Our reference: P-675541-Y8Z7  
Contact: Sandra Fagan  
Telephone: (02) 4732 7992

**Council Response to Modification Report for SSD-9522-Mod-6, Kemps Creek Estate Warehouse, Logistics and Industrial Facilities Hub (The Yards/Altis/Frasers) at 657 - 769 Mamre Road, Kemps Creek, NSW, 2178.**

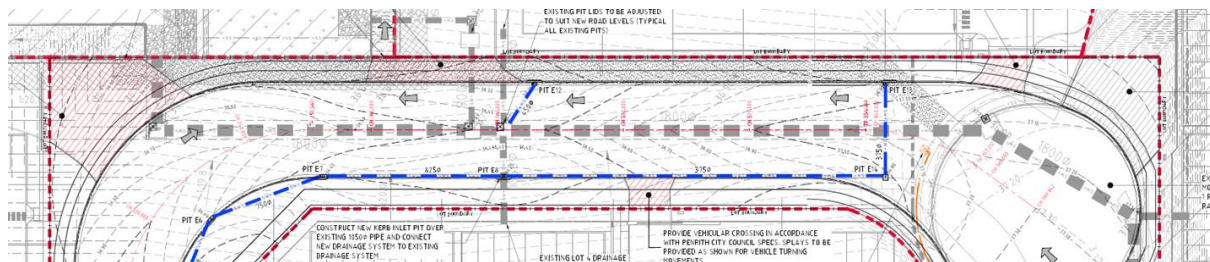
- a) In principle there is no technical objection to the proposal. However, in accordance with Council's specifications the stormwater drainage pipes within public roads should be located longitudinally under the kerb and gutter alignment. The proposal includes the retention of an existing stormwater drainage pipe and pits located centrally within the road carriage way. This is not supported by Council and will require the drainage pipe and pits to be relocated underneath the kerb and gutter alignment. Please refer to the below extract showing the subject existing stormwater pipe in grey.
